DEVELOPMENT REVIEW BOARD STAFF REPORT

Hearing Date: April 14, 2016	
Case No: DRB 2016-14	
Application(s): 2-lot Minor Conventional Subdivision Sketch Plan	
Application Received: March 11, 2016	
Application Deemed Complete: March 11, 2016	
Staff Report Finalized: Friday, April 7, 2015	
Applicant(s): Erwin Devino 243 North Road Milton, VT 05468	Owner(s): Same
Engineer/License: Karl Marchessault, PE Civil 8932 O'Leary-Burke 13 Corporate Drive Essex Junction, VT 05452	Surveyor/License: Seth W. Kittredge, LS 060709 O'Leary Burke 13 Corporate Drive Essex Junction, VT 05452
E-911/Postal Address: 242 North Road	
Tax Map, Parcel(s): 15, 119-1	
School Parcel Account Number(s) (SPAN): 10952	
Deed(s): Book 61, Page 96-98	
Existing Size: 1.05 acres	
Zoning District(s): Old Town Residential (R1)	
Comprehensive Plan Planning Area/Sub-Area: North Road Planning Area	
Location: On the west side of North Road Between Quarry Lane and Husky Road.

Devino Subdivision
243 North Road
Milton, VT

Overall Plan & Details

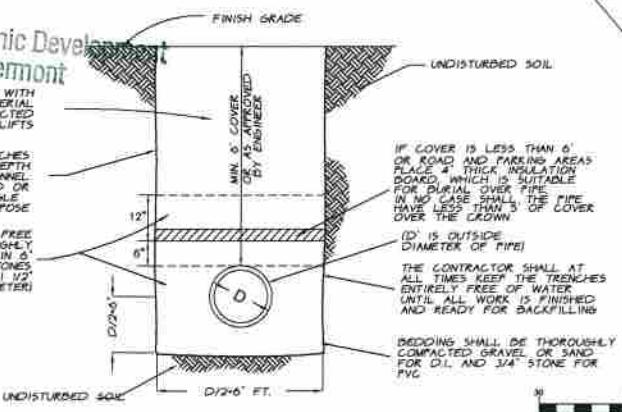
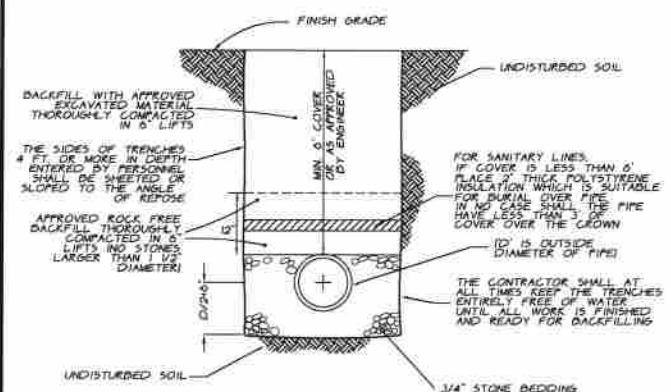
Proposed Improvements: The applicant is proposing an additional single family residence to be constructed on the property. The new residence would be served by its own drive, and municipal water service. The proposed connection to municipal sewer would be made via a connection to existing sewer service on Lot 1 via a 20' wide sewer easement on Lot 1.

Proposed Restrictions or Covenants: The applicant proposes a 20' sewer easement on Lot 1 to benefit Lot 2.

4. The DRB may require that street trees be planted along North Road in accordance with SR830.
5. If required, the final plan application shall include the location of street trees along North Road pursuant to SR830.

6. The Applicant shall obtain a water & wastewater allocation from the Department of Public Works prior to submitting a Final Application.

7. The proposed driveway shall be constructed according to ZR593 and the driveway specifications as defined in the Public Works Specifications.
